Access Compliance Report

Public Rights-of-Way

Intersection ID: 10776	Main Street: CAROL_AV	Cross Street: STATE_ST	Location: W
ADA ID: AA49F7C3CADC	Ramp Type: Perp	Initial Pass/Fail: Fail	Overall Compliance: No
		Severity Score: 25

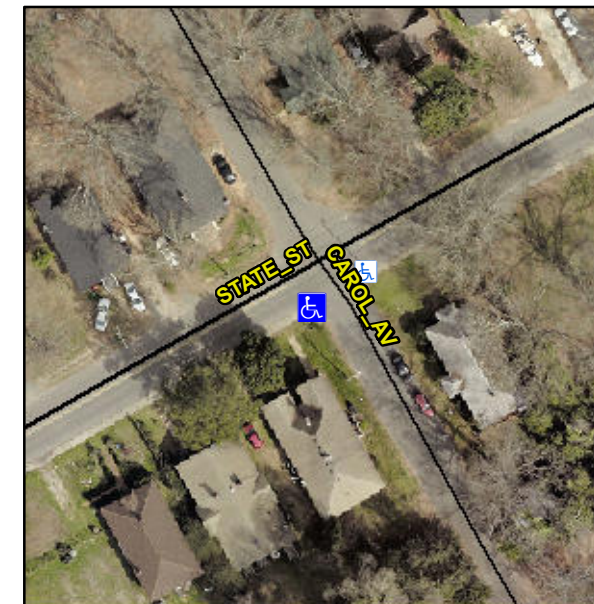
R304.5.3

Compliance	Description	Data	Compliance	Description	Data
N/A	Ramp Length (in)	67.0	Yes	Ramp Slope (%)	6.2
Yes	Ramp Width (in)	48.0	No	Ramp XSlope (%)	14.0
N/A	Flare Type LT	N/A	N/A	Flare Type RT	N/A
N/A	Flare Slope LT (%)	N/A	N/A	Flare Slope RT (%)	N/A
N/A	Flare Traversable LT?	N/A	N/A	Flare Traversable RT?	N/A
N/A	Landing Length (in)	N/A	N/A	DWS Provided?	N/A
N/A	Landing Width (in)	N/A	N/A	DWS Contrast?	N/A
N/A	Landing Slope (%)	N/A	N/A	DWS Length (in)	N/A
N/A	Landing X Slope (%)	N/A	N/A	DWS Full Width?	N/A
N/A	Landing Curb? (Y/N)	N/A	N/A	DWS Offset (in)	N/A
N/A	Shared Landing?	N/A			
N/A	Gutter Ponding?	N/A	N/A	Gutter Slope (%)	N/A
N/A	Gutter Lip Ht (in)	N/A	N/A	Gutter X Slope (%)	N/A
N/A	Painted X Walk1?	No	N/A	Painted X Walk2?	N/A
	X Walk 1 Direction	To E		X Walk 2 Direction	N/A
N/A	X Walk 1 Width (in)	N/A	N/A	X Walk 2 Width (in)	N/A
	X Walk 1 Slope (%)	1.2		X Walk 2 Slope (%)	N/A
	X Walk 1 X Slope (%)	6.5		X Walk 2 X Slope (%)	N/A

Remove & Replace Entire Ramp.
